Justification for Class III Permit Modification March 2005 SWMU 135 Operable Unit 1303 Building 906 Drain System at Technical Area II

SWMU 135
Operable Unit 1303
Building 906 Drain System at Technical Area II

Comment Responses to USEPA May 1995

**REQUEST FOR SUPPLEMENTAL INFORMATION
RESPONSE FOR DRAIN AND SEPTIC SYSTEMS
SWMU 135, BUILDING 906 DRAIN SYSTEM AT
TECHNICAL AREA II**

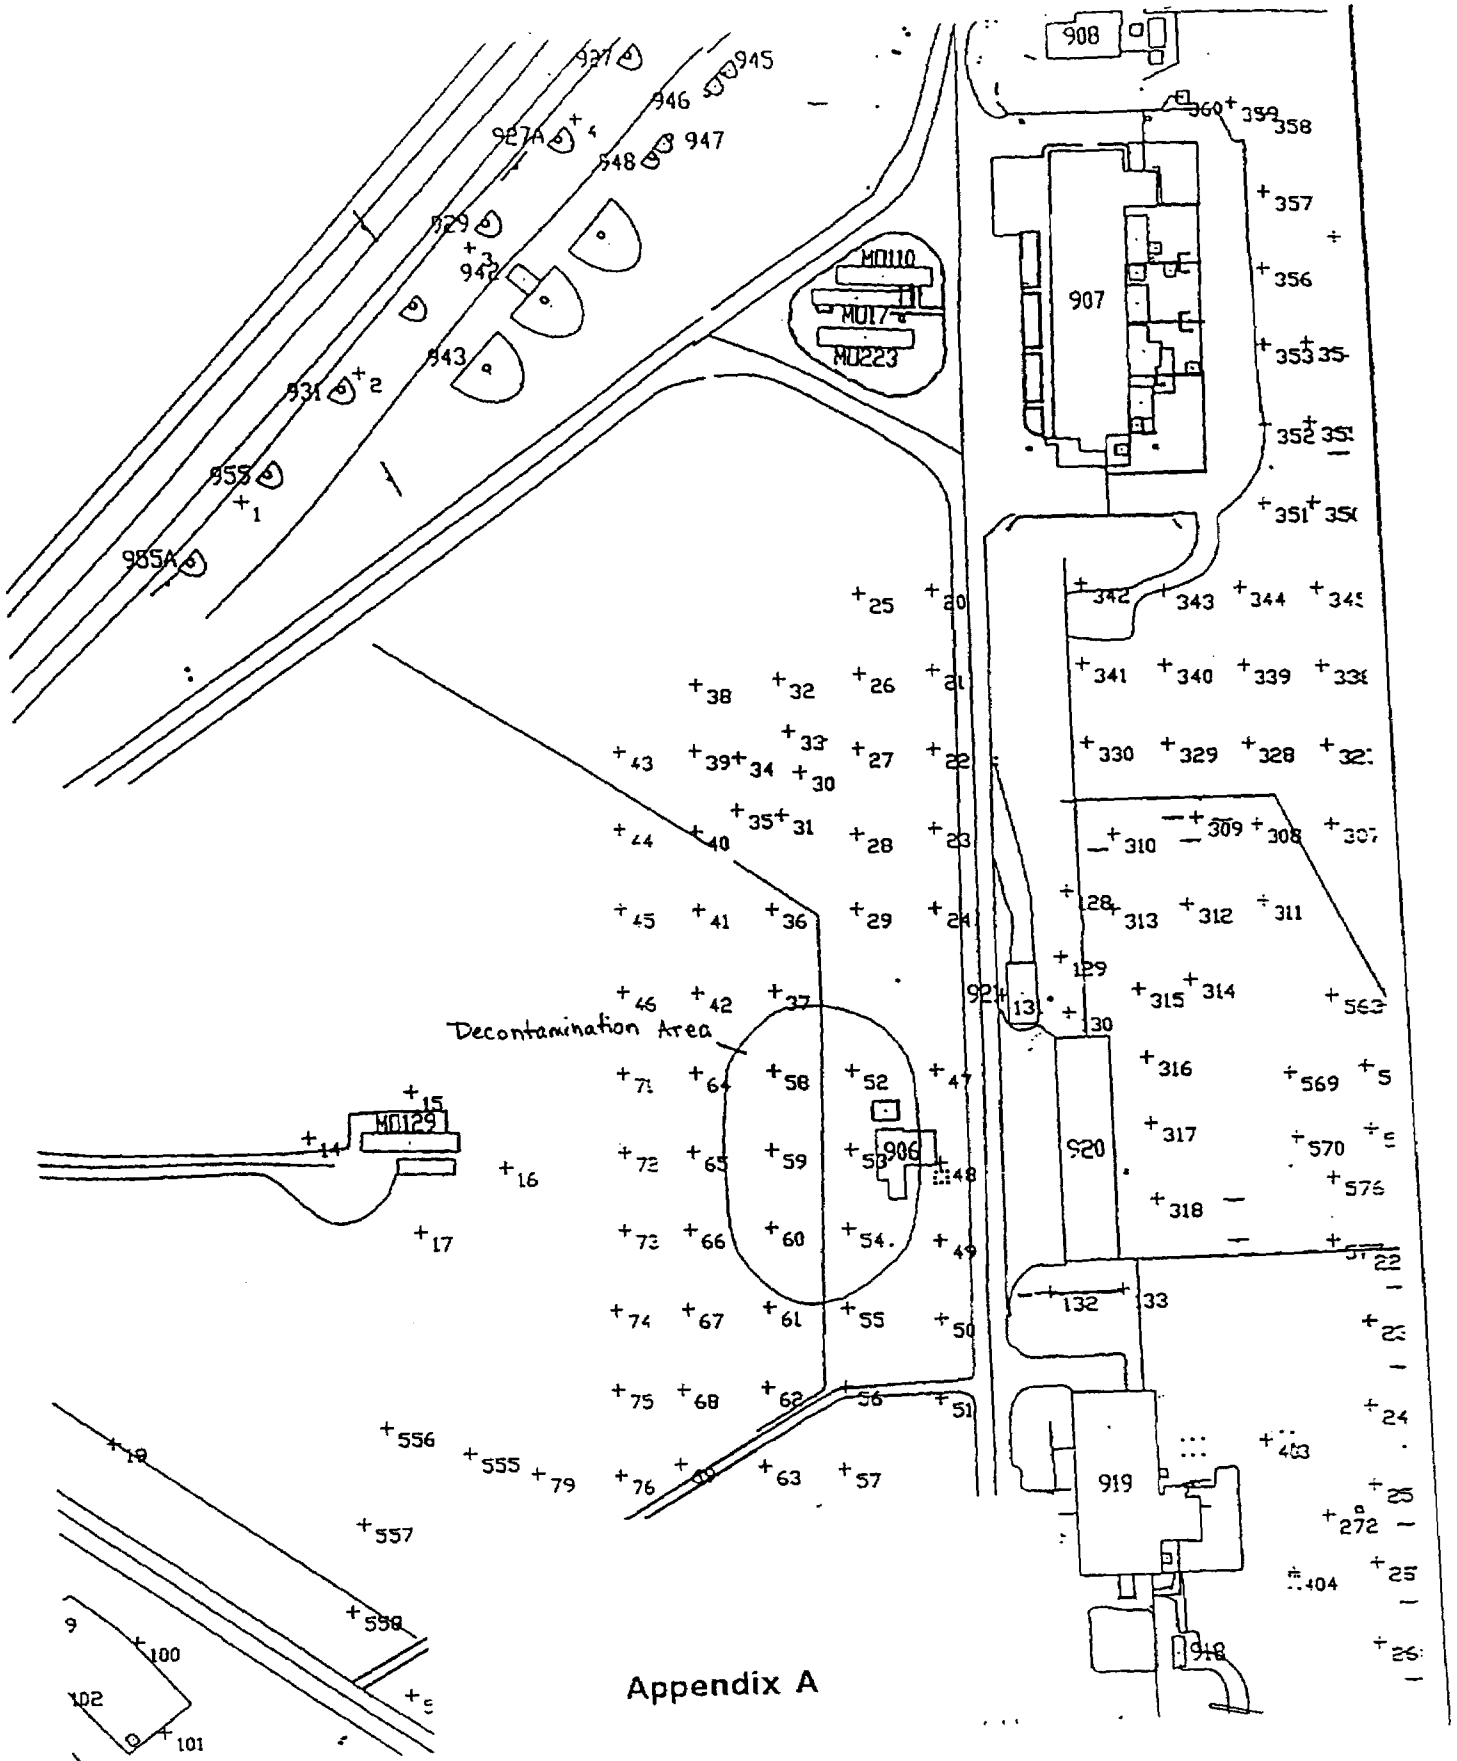
Comment (c). Sandia should provide a better figure showing the location of the dry well, borehole, leachfield, and new ground water monitoring well. Also, please provide additional information concerning the newly installed monitoring well. How frequently is the well sampled? Which analyses are performed?

Response (c). A figure is attached (Appendix C) showing the locations of the dry well, leachfield, and borehole/monitoring well. Borehole TA2-BH-01 (drilled in March 1994) was completed in June/July 1994 as monitor well TA2-W-01 (see Appendix C). Except for the first quarter of 1995, ground-water samples have been and will continue to be collected from monitor well TA2-W-01 on a quarterly basis for an entire suite of chemicals, including organics, inorganics, cations, anions, total dissolved solids, and metals.
